Minneapolis & Golden Valley Community Meeting – June 4th, 2015

Minneapolis & Golden Valley Open House – June 4, 2015

METRO Blue Line LRT Extension (BLRT)

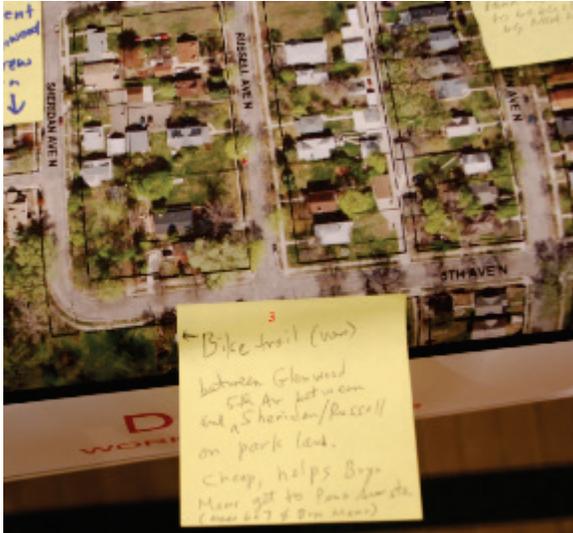
1. Consider alignments that save the trees.

2. Major Economic Development w/ Push @ Glenwood, Bryn Mawr Brea & others.

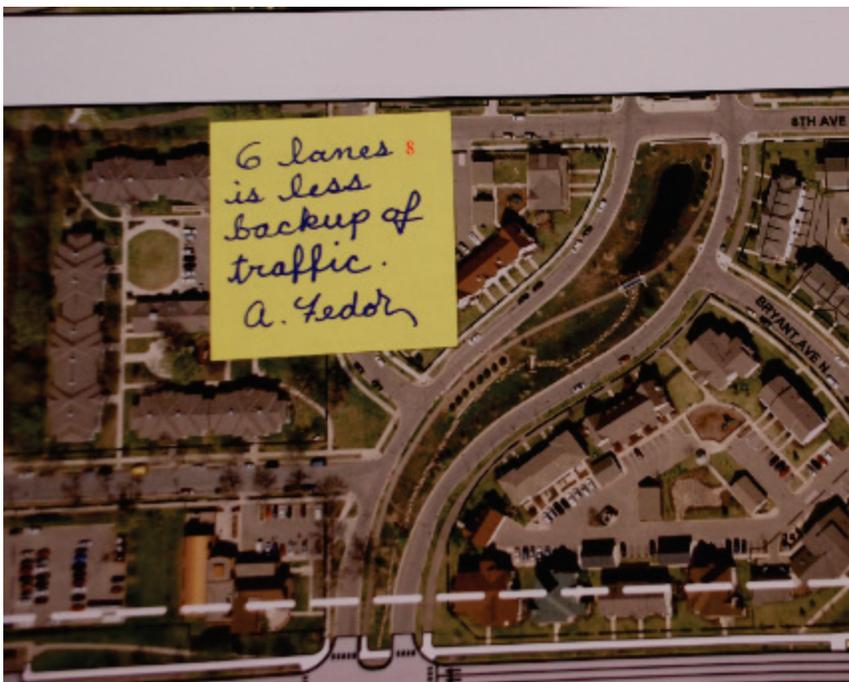
- 3. Bike trail (new) between Glenwood and 5th Av between Sheridan/Russell on park land. Cheap, helps Bryn Mawr get to Penn Ave Sta. (areas 6 & 7 of Bryn Mawr)**

- 4. Golden Valley Business**

5. Golden Valley BRT/Streetcar

6. 1) It would shorten connection to SWLRT for Western North Minneapolis 2) It makes it possible Penn Ave SWLRT Station to be built & be used by North Minneapolis

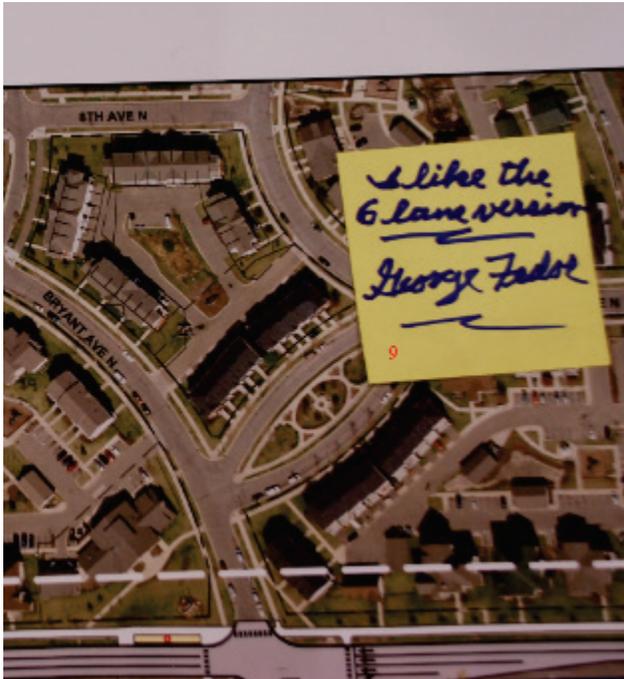
9. I like the 6 lane version

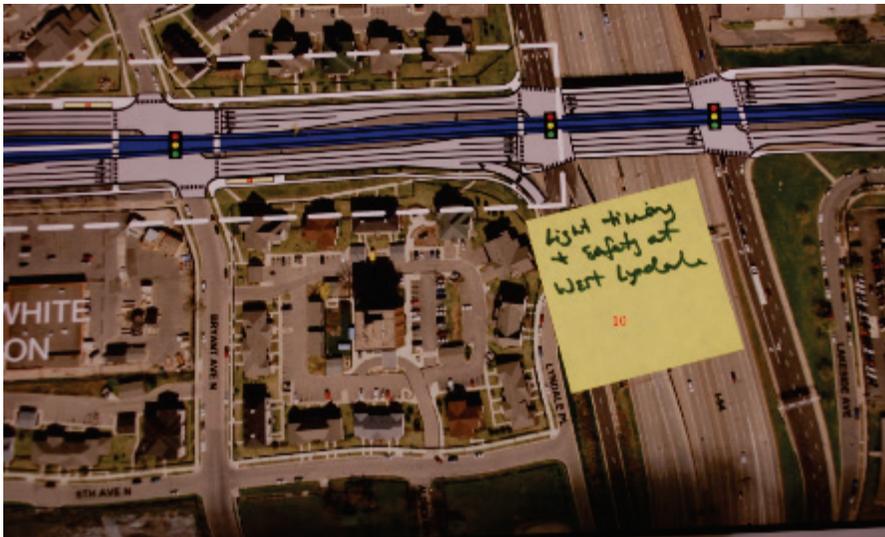
10. Light timing and safety at West Lyndale

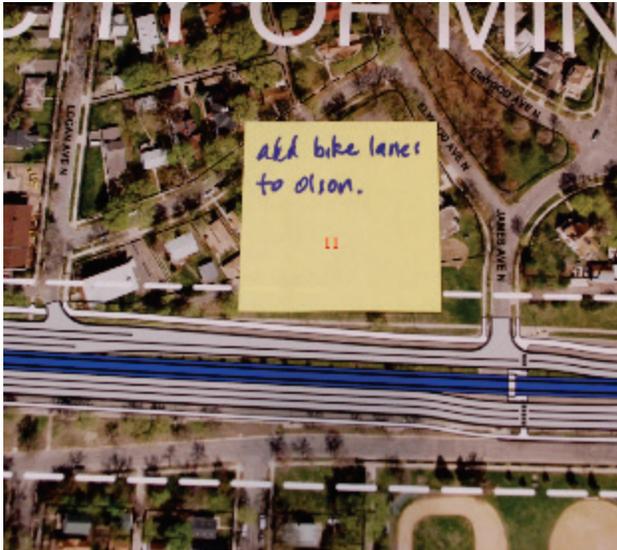
11. Add bike lanes to Olson

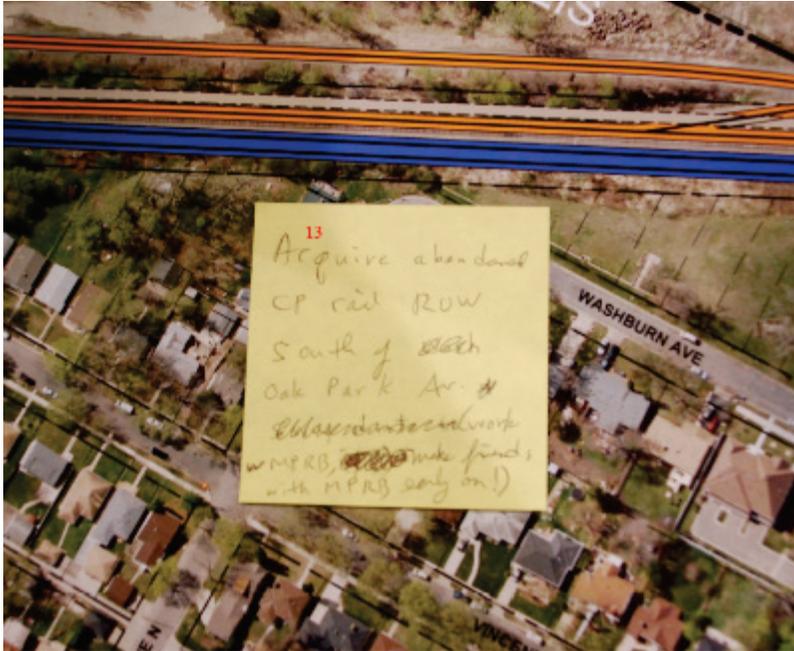
13. Acquire abandoned CP rail ROW South of Oak Park Av. Work w/ MPRB, make friends with MPRB early on!

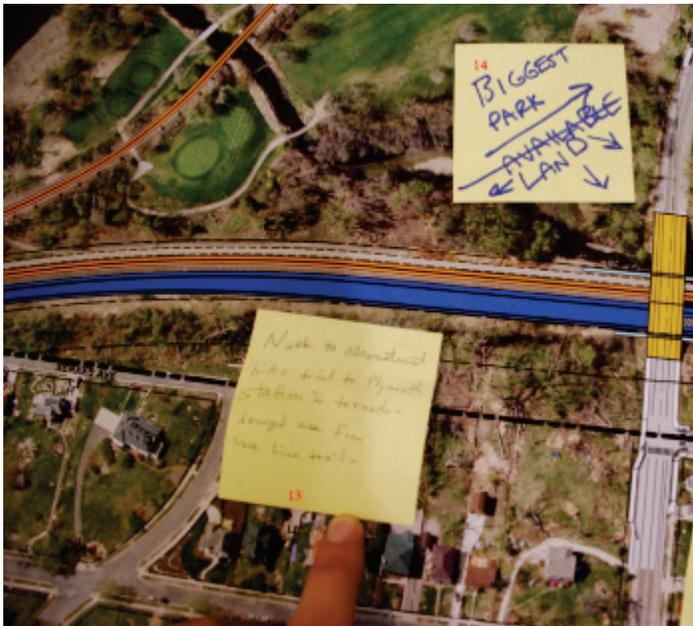
13. Need to reconstruct bike trail to Plymouth Station in tornado damage area from Luce Line trail.

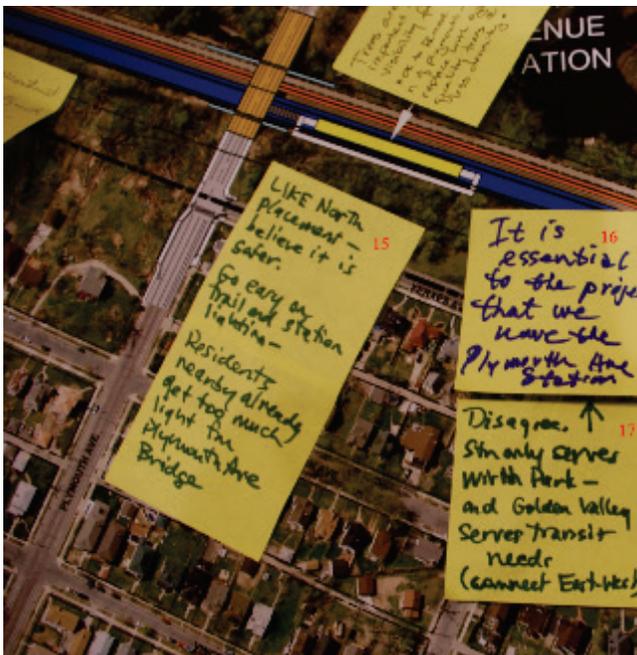
15. Like North placement—believe it is safer. Go easy on trail and station lighting – residents nearby already get too much light from Plymouth Ave Bridge

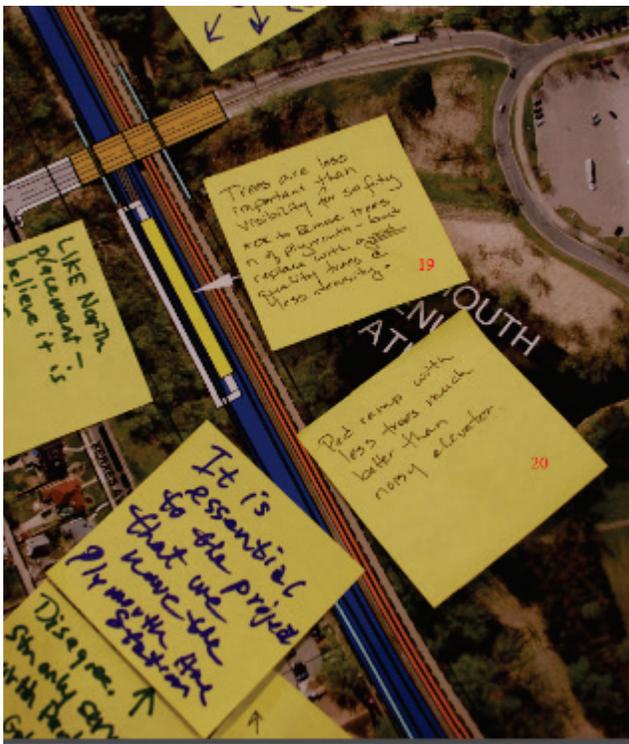
19. Trees are less important than visibility for safety. Ok to remove trees n of Plymouth – but replace with good quality trees @ less density.

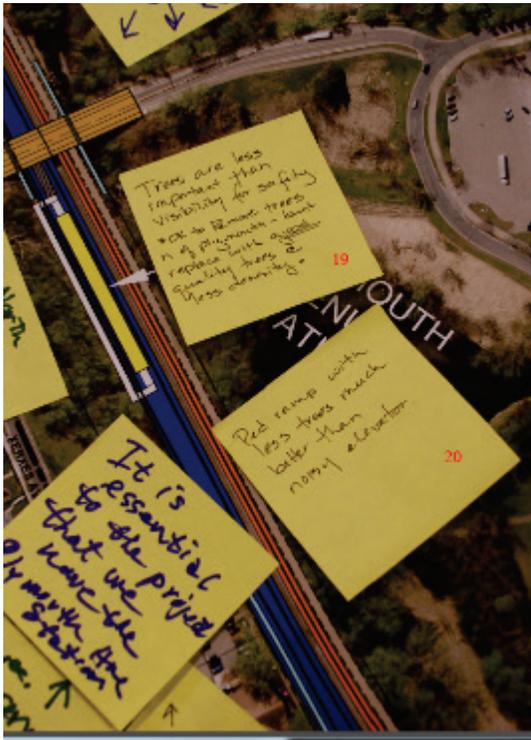
20. Ped ramp with less trees much better than noisy elevator.

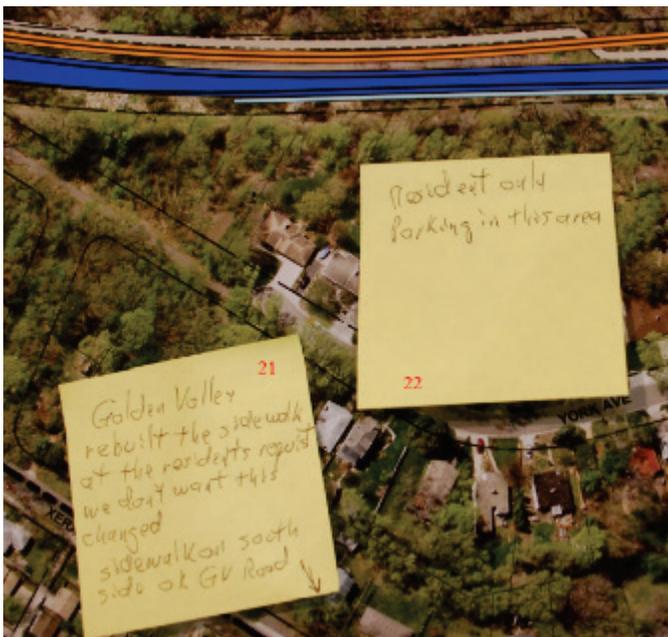
21. Golden Valley rebuilt the sidewalk at the resident's request we don't want this changed. Sidewalk on south side of GV Road.

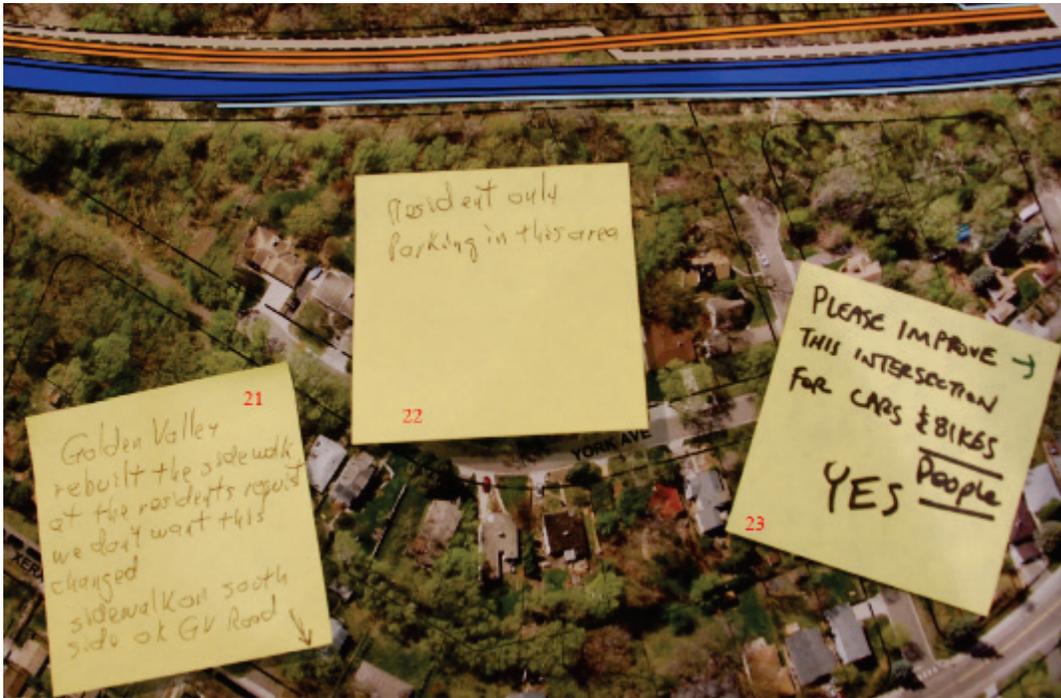
22. Resident only parking in this area

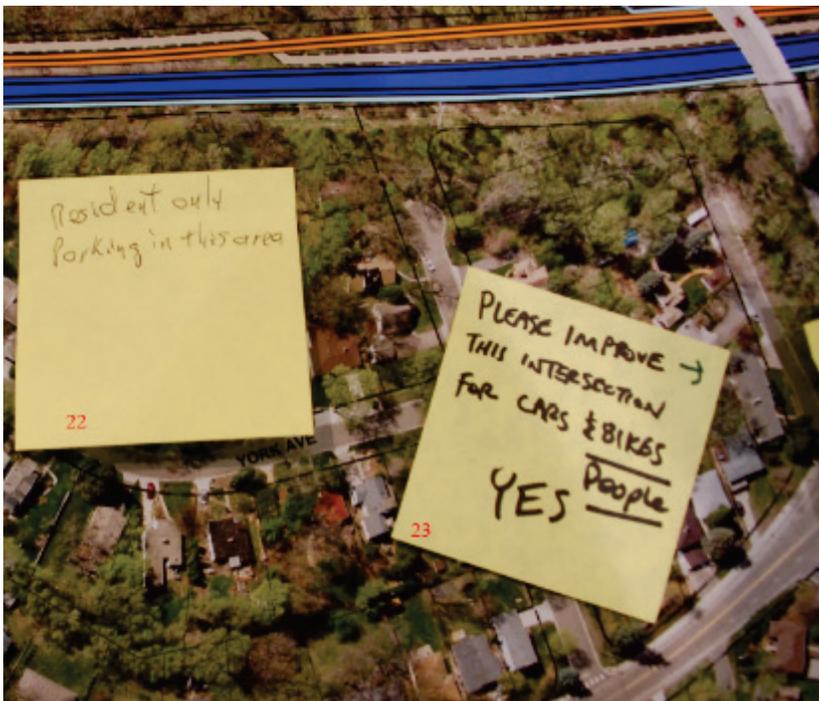
23. Please improve this intersection for cars & bikes. People. YES

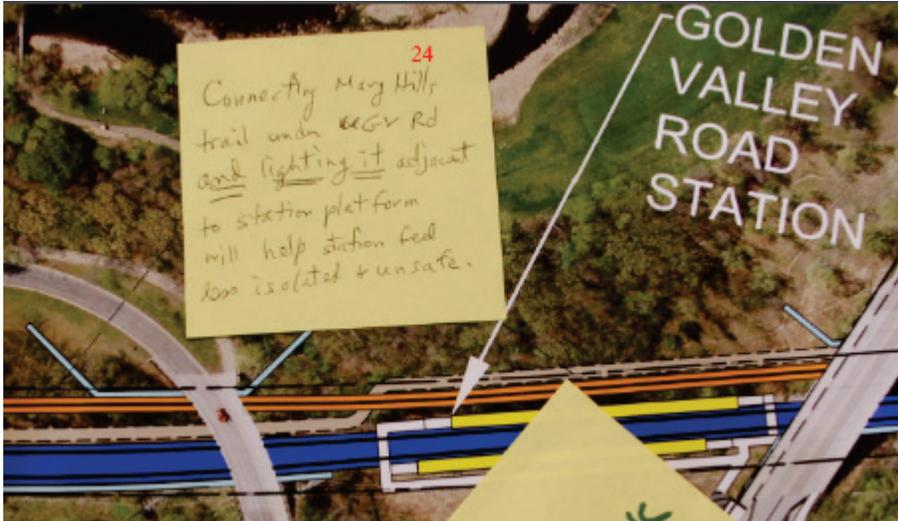
24. Connecting Mary Hills trail under GV Rd and lighting it adjacent to station platform will help station feel less isolated & unsafe.

27. Might this be a roundabout? If so, say it

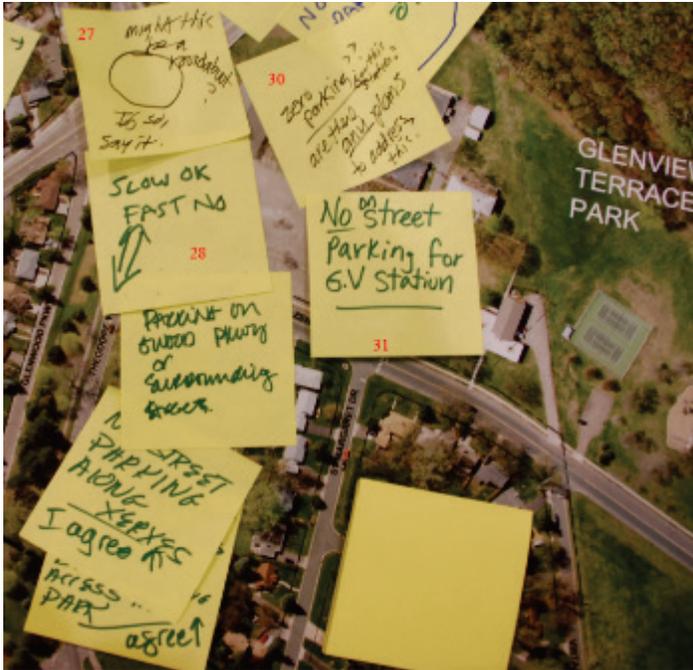
28. Slow ok. Fast no. Parking on Gwood Pkwy or surrounding streets. No street parking along Xerxes. I agree.

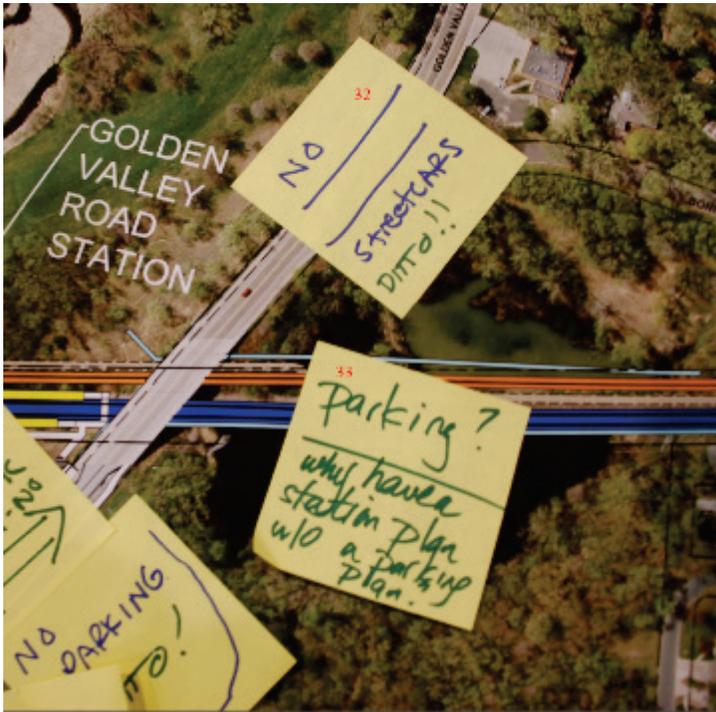
30. Zero Parking?? For this station?? Are there any plans to address this?

31. No on street parking for G.V station

32. No Streetcars. DITTO!!

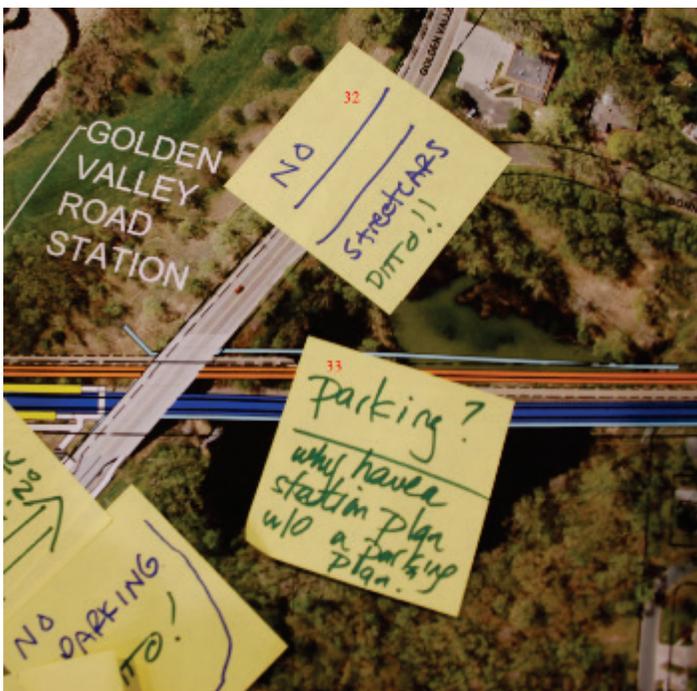
33. Parking? Why have a station plan w/o a parking plan.

34. Do NOT Need a Sidewalk on Bass Cr. Dr. AGREE

35. Proposed sidewalk – would be on which side of Parkview?

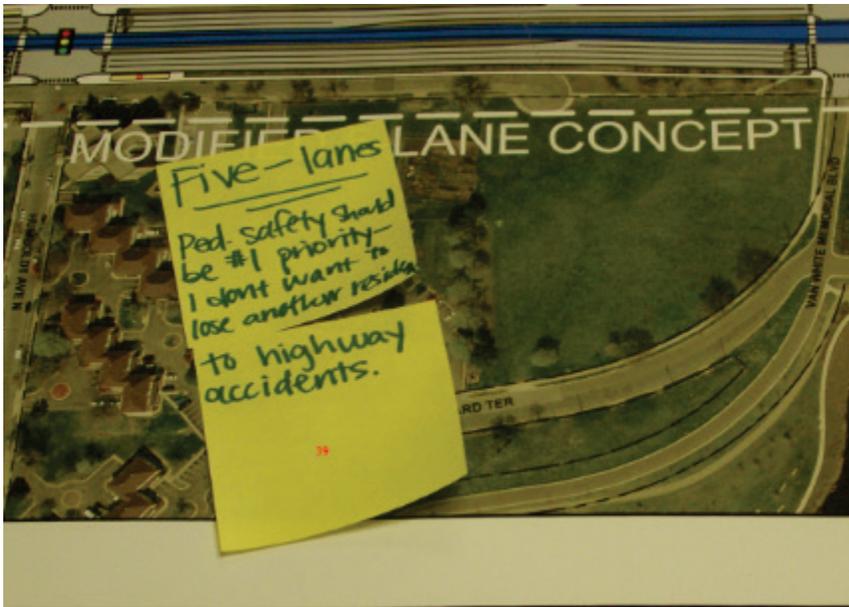
38. Yes. BLRT should continue down Penn to SWLRT Station @ 394

39. Five-lanes. Ped. safety should be #1 priority – I don't want to lose another resident to highway accidents.
